Technical Change of 2C 302-135 P01/P03

2C 302-135 P01/P03

2C 306-135 P01/P03

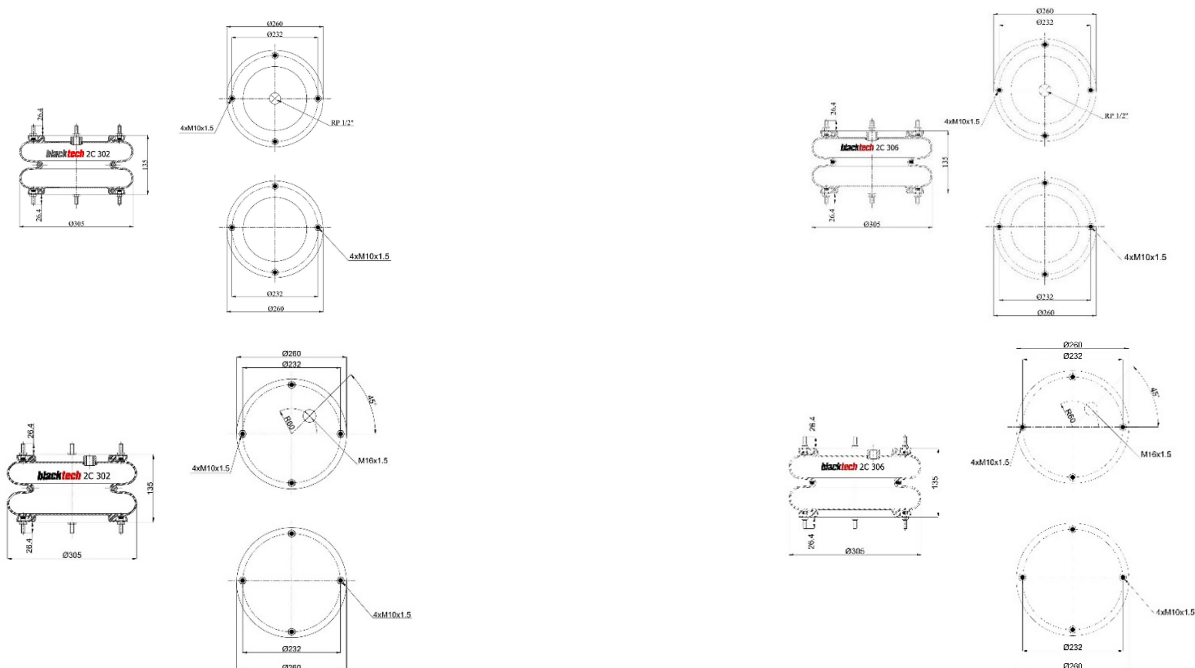
In order to improve the efficiency of former Blacktech Versions **2C 302-135 P01** and **2C 302-135 P03**, we will switch to the revised versions **2C 306-135 P01** and **2C 306-135 P03**. In this case we will use instead of the metal ring, a steel ring consisting of a combination of many wires, which will be implemented during the vulcanization process. This will have a positive effect on the durability of our products.
